## AIR RESERVOIRS: CHANGE OF THREADED RING OUTSIDE DIAMETER

WABCO air reservoir with new threaded ring (outside  $\varnothing 32$  mm)

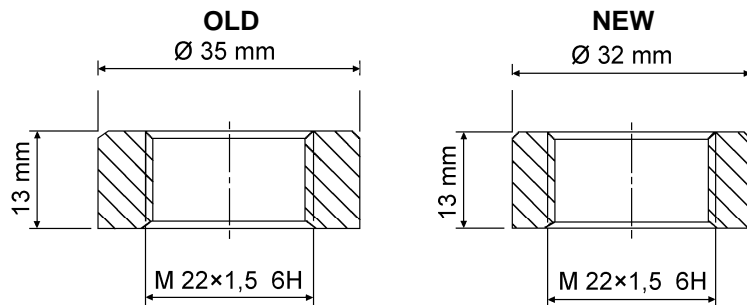
For reasons related to the harmonisation of production at WABCO's supplier, the outside diameter of the threaded ring for 30 air reservoirs will be changed from  $\varnothing 35$  mm to  $\varnothing 32$  mm.

- The change does not affect the functionality of air reservoir
- Inner threads M 22x1.5 mm are not changed
- The outside dimensions of threaded rings are not stated in WABCO drawings
- Declaration of conformity acc. EN 286-2 is available at our product catalogue [INFORM](http://inform.wabco-auto.com) (inform.wabco-auto.com) by entering the product number in the search field "Product Number" and clicking the radio button "Publication".
- The change will be implemented at the production line in August 2013
